SUBJECT: Indian Point 2 and 3 Nuclear Power Plants
Docket Nos. 50-247 and 50-286
License Nos. DPR-26 and DPR-64
"Supplement to 15-Day Response for NRC Bulletin 2002-01"

**SUPPLEMENT TO 15-DAY RESPONSE TO
NRC BULLETIN 2002-01
FOR INDIAN POINT UNIT 2**

FOR INDIAN POINT UNIT 3

FIGURE I
 UNIT 2 REACTOR VESSEL HEAD
 LEAK LOCATIONS AND INSULATION REMOVAL

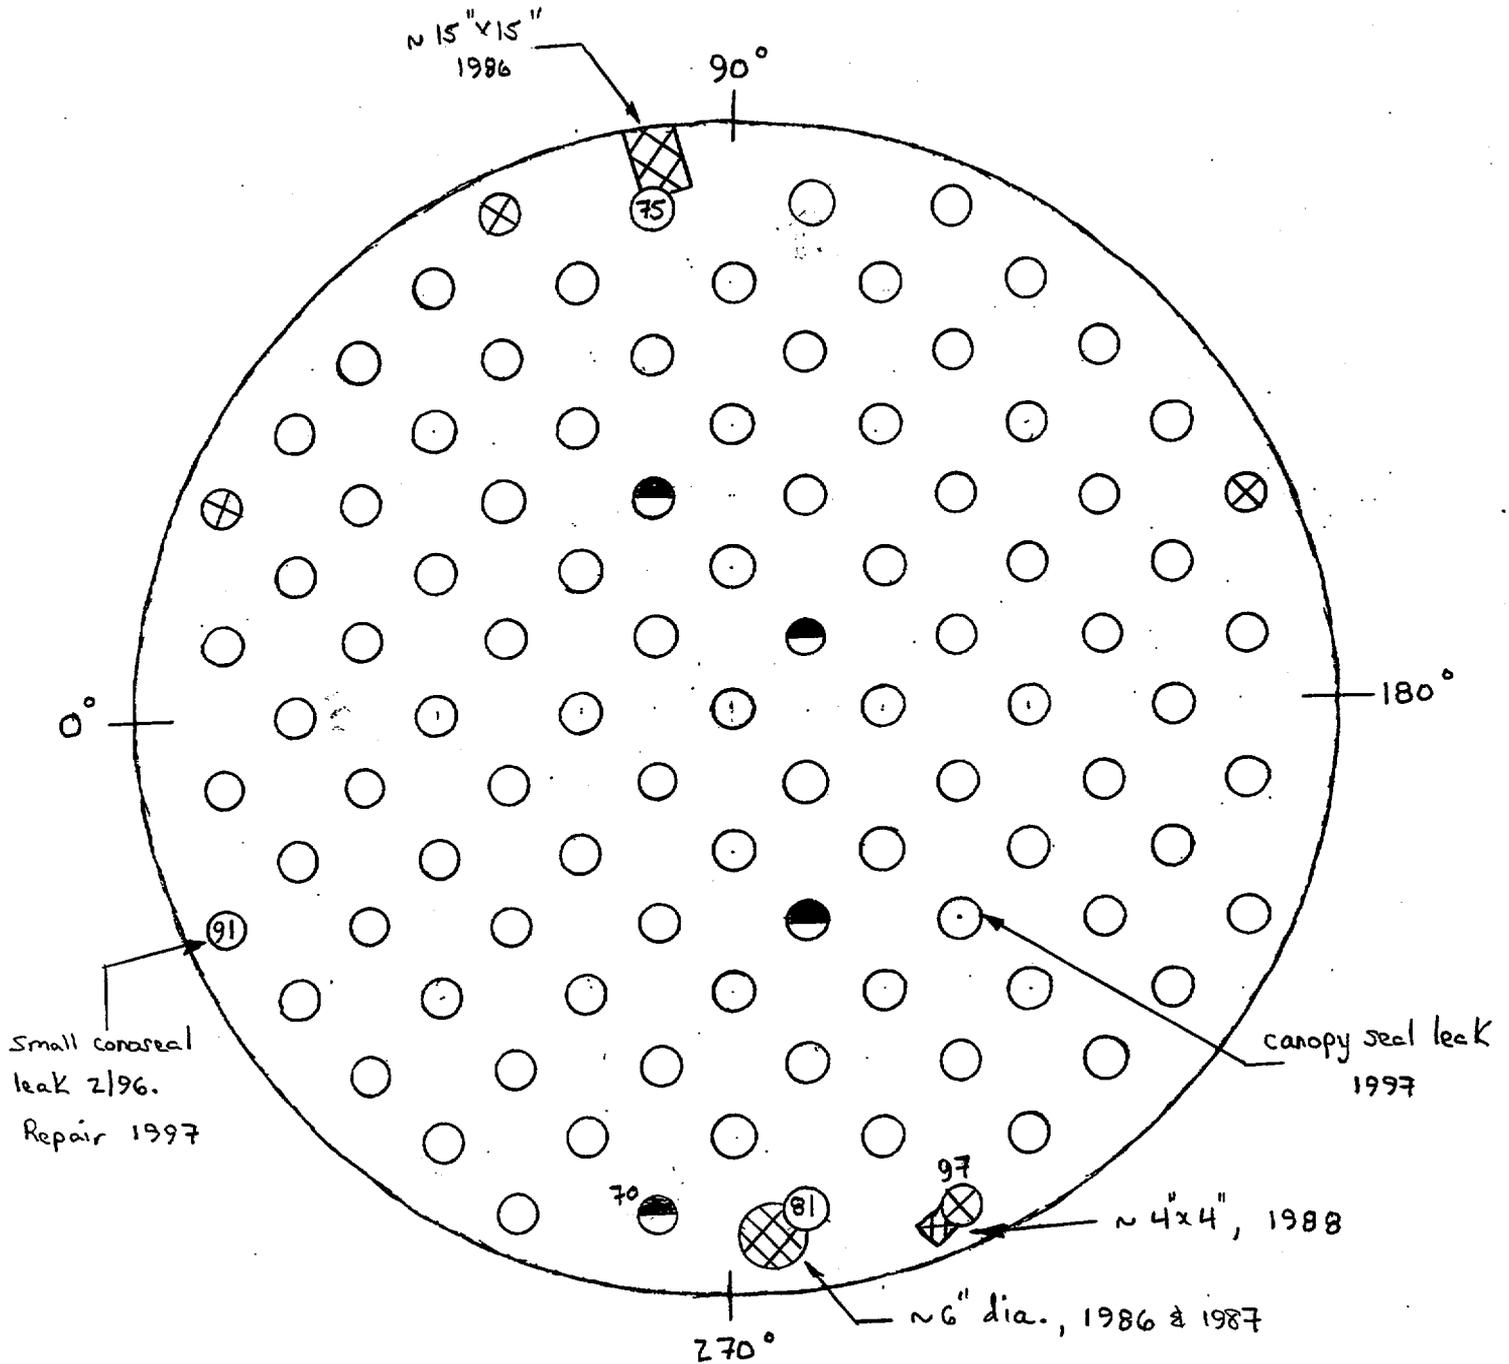
Your 15 day response to Bulletin 2002-01 indicates that sections of insulation adjacent to leaking canopy seal welds were removed in 1986, 1987, and 1988, and a bare-metal inspection of the reactor vessel head was performed. Provide a sketch of the location of the leaks and the locations where the insulation was subsequently removed for each occurrence. Discuss the size (area) of the insulation that was affected by the leaks and the size (area) of the base metal that was exposed. Discuss whether or not any boric acid deposits and/or residue were identified on the bare metal of the head and/or whether any boric acid/water penetrated the insulation.

Removal of insulation and inspection of the bare metal was performed as described below. Locations are shown on Figure I.

- 1986: Approximately 6 inch diameter section removed between nozzles 70 and 81.
Approximately 15 inch x 15 inch section removed adjacent to nozzle 75.
- 1987: Same location as 1986, between nozzles 70 and 81.
- 1988: Approximately 4 inch x 4 inch section removed adjacent to nozzle 97.

In all above cases, no boron accumulation on the vessel head or degradation of base metal was observed, and the head coating (high-temperature aluminum silicate) appeared to be intact. During the 1986 / 1987 inspection and repair efforts, samples of insulation were tested to determine the degree to which the leaking, borated water had penetrated the head insulation. The results of these tests showed that, although the insulation provided some protection against the leaking water contacting the head base metal, some boron was found through the thickness of the insulation, indicating that the insulation is not water tight. However, no visible signs of boron were found on the vessel head.

FIGURE II
 UNIT 3 REACTOR VESSEL HEAD
 PENETRATIONS AND CLOSURE STUD LOCATIONS

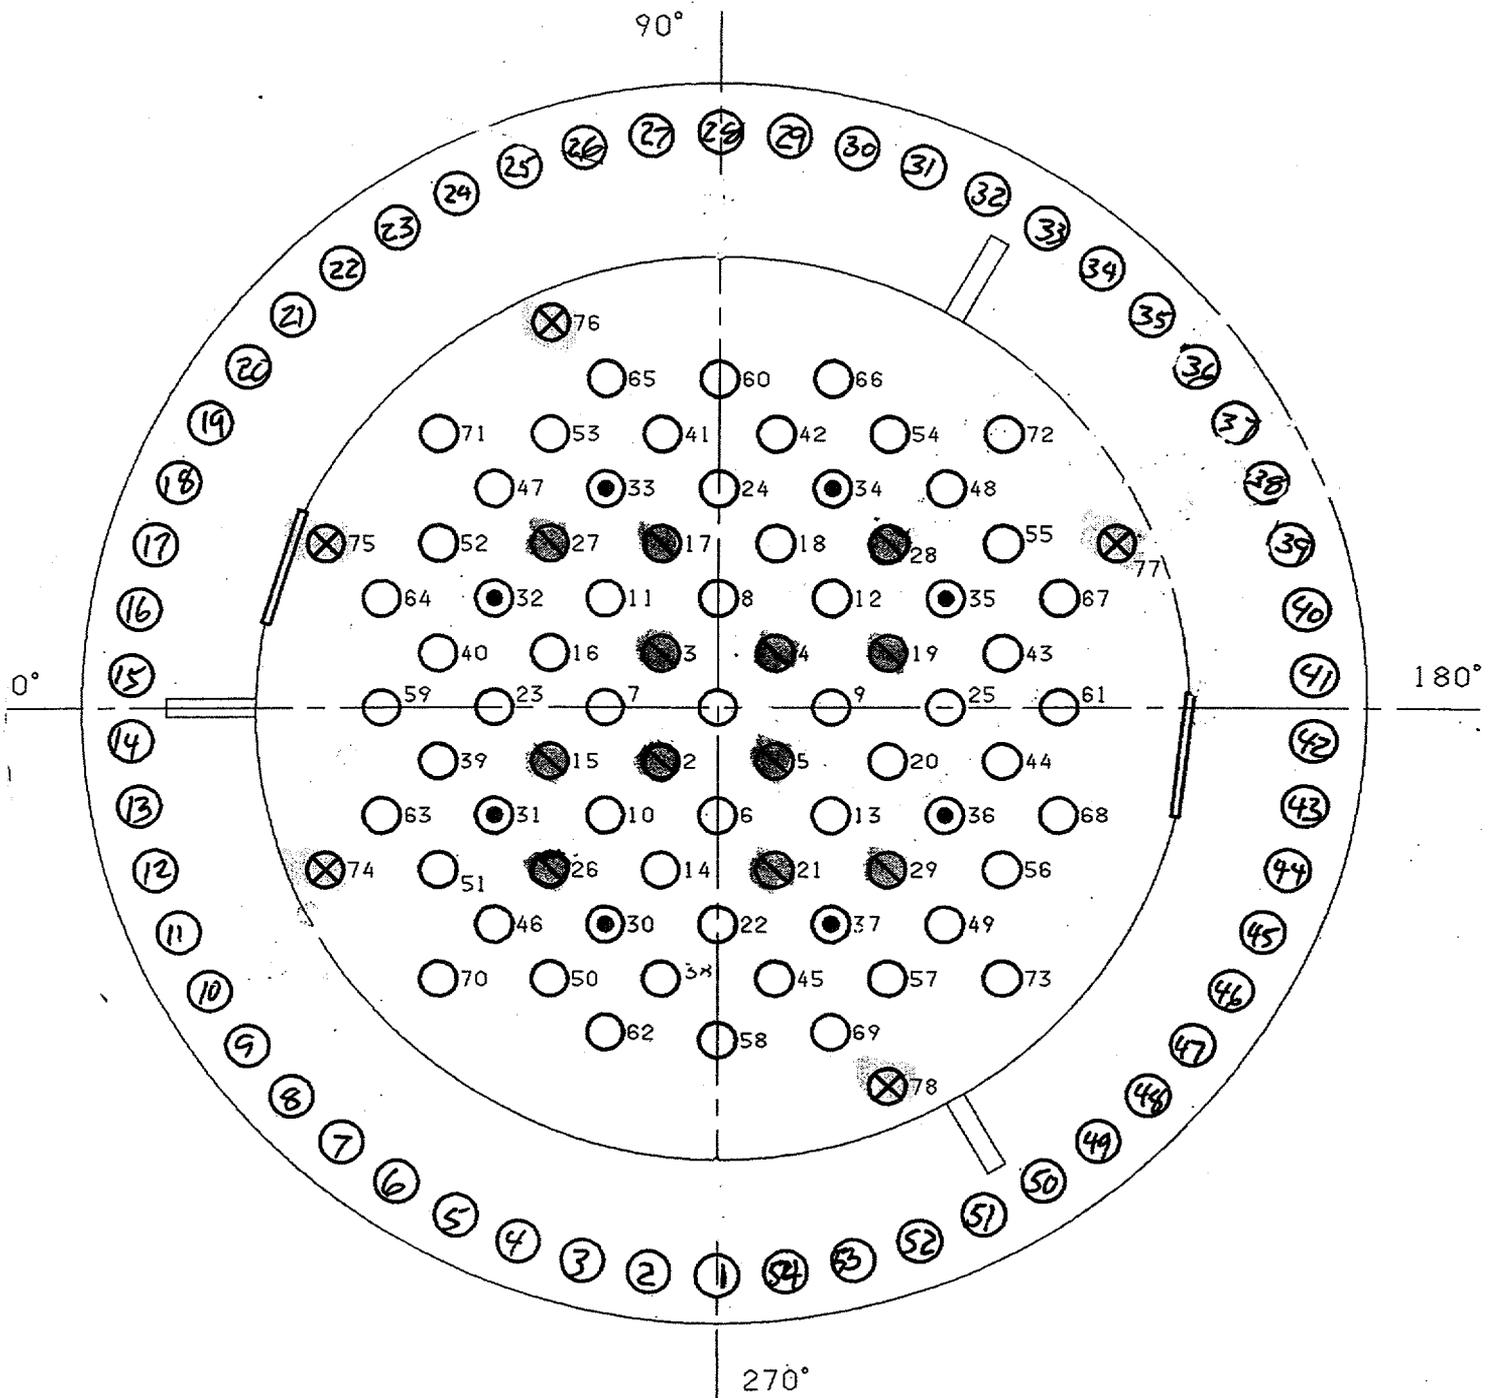
Your 15 day response to Bulletin 2002-01 indicated that insulation around 14 CRDMs was removed, and inspections were performed due to a canopy seal leak that was identified in 1990. Discuss whether or not any boric acid deposits and/or residue were identified on the bare metal of the head and/or whether any boric acid/water penetrated the insulation. Clarify whether or not this area is still accessible, and if accessible, discuss the inspections that have been performed.

A plan view of the Unit 3 reactor vessel head is provided in Figure II to show the relative locations of areas described in answers to several of the NRC questions.

Leakage from the canopy seal on CRDM 28 was detected during startup from a scheduled outage in March 1990. A clamp assembly was installed (Work Request 21446) to repair the leak and the wetted insulation over an area approximately 3 feet by 5 feet was removed (Work Request 21284). In addition, a clamp assembly was installed on CRDM 26 (Work Request 21447) because boric acid residue was found on the canopy seal area, although no active leakage was detected. Prior to installing new insulation, the reactor vessel head was cleaned and inspected in the area of removed insulation. No corrosion was noted in the work package documentation.
